PLAN REVIEW SHEET

2014-044

C. Grey Poole, Selwyn Property Group

Below is an image of the standard detail (60.01B) for the requested bus stop pad. The site plan may either show the conceptual location of the improved bus stop on Park Road, or alternatively, include a development note to locate the bus stop pad during the development review and permitting process.

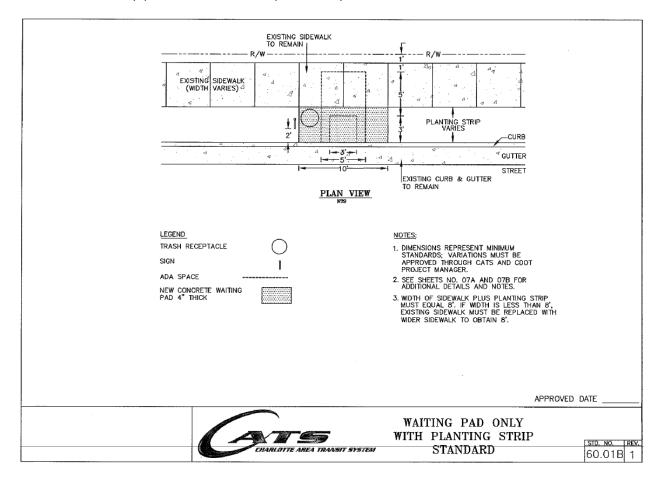
The Petitioner is requested to provide and construct a concrete waiting pad for the existing bus stop along Park Road. The bus stop location may move to the north in order to avoid blocking the proposed driveway. The waiting pad should be spaced midway between proposed street trees within the planting strip and aligned with new sidewalk concrete panels.
